AGENDA
SUBDIVISION AND UTILITY ADVISORY COMMITTEE
Thursday, September 15, 2016
10:00 A.M.

The regular meeting of the Subdivision Committee of the Metropolitan Area Planning Commission will be held on Thursday, September 15, 2016 at 10:00 a.m. in the Planning Department Conference Room, **271 Building, 2nd Floor, 271 W. Third Street**, Wichita, Kansas.

2. **SUB2016-00023: Final Plat – FIREFLY WAY ADDITION;** located west of 127th Street East on the south side of 29th Street North.

SAVANNA AT CASTLE ROCK RANCH 5TH ADDITION TO SEDGWICK COUNTY, KANSAS

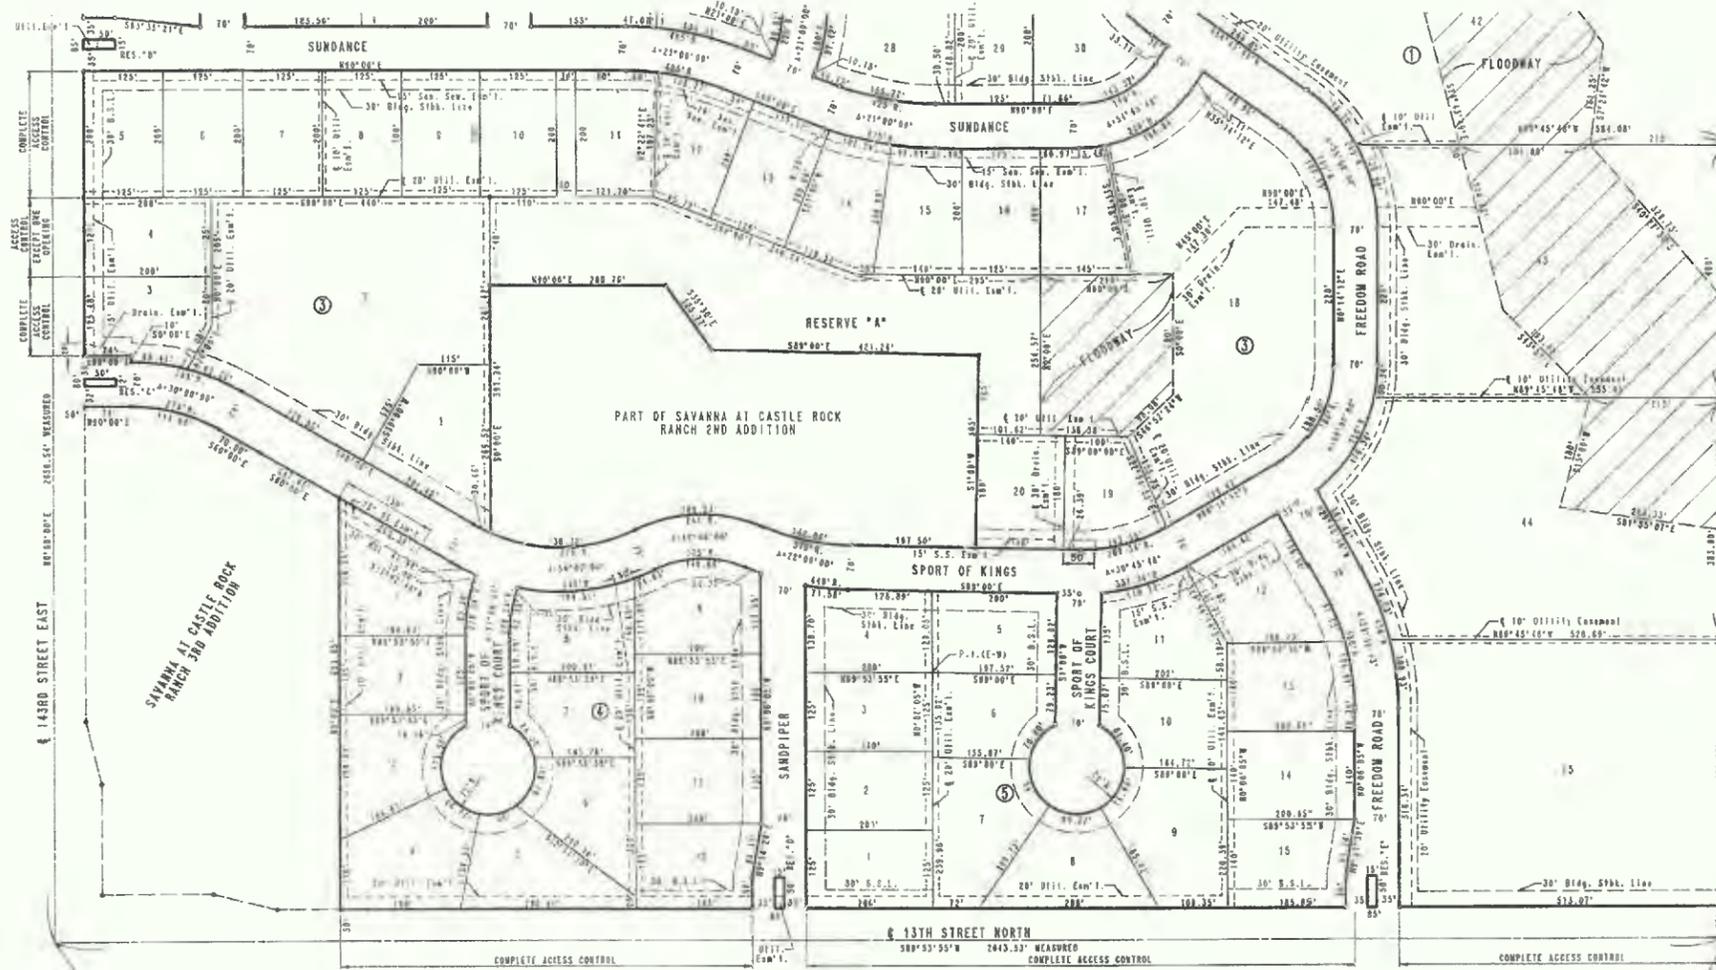
The applicants propose to vacate the east 11 feet of the platted 30-foot front yard building setback located on and running parallel to the west lot/property line of the SF-5 Single-Family Residential zoned corner lot, Lot 4, Block 5, Savanna at Castle Rock Addition. Per the Unified Zoning Code's (UZC) the shorter of the two street frontages of a corner lot is the front yard; the west side of the lot that has Sandpiper Street frontage is the front yard. The UZC minimum front yard setback standard for the SF-5 zoning district is 25 feet. There are no platted easements located in the subject front yard building setback. There is no public water, sewer or stormwater located in the subject front yard setback. A Google image of the site shows no utility poles located in the area of the proposed vacation. Comments from franchised utilities have not been received and are needed to determine if they have utilities located within the subject easement. The applicants have provided an e-mail that purports to having approval by the Home Owners Association. The Savanna at Castle Rock Addition was recorded with the Register of Deeds January 7, 1994.

Conditions (but not limited to) associated with the request:

- (1) Vacate the east 11 feet of the of the platted 30-foot front yard setback located on and running parallel to the west lot/property line of the SF-5 Single-Family Residential zoned corner lot, Lot 4, Block 5, Savanna at Castle Rock Addition. Provide Planning Staff with a legal description of the approved vacated portion of the setback on a Word document, via e-mail, to be used on the Vacation Order and Vacation Petition. This must be provided to Planning prior to the case going to Council for final action.

- (2) Any relocation or reconstruction of utilities made necessary by this vacation shall be the responsibility and at the expense of the applicant. Provide any needed easements prior to the case going to Council for final action.
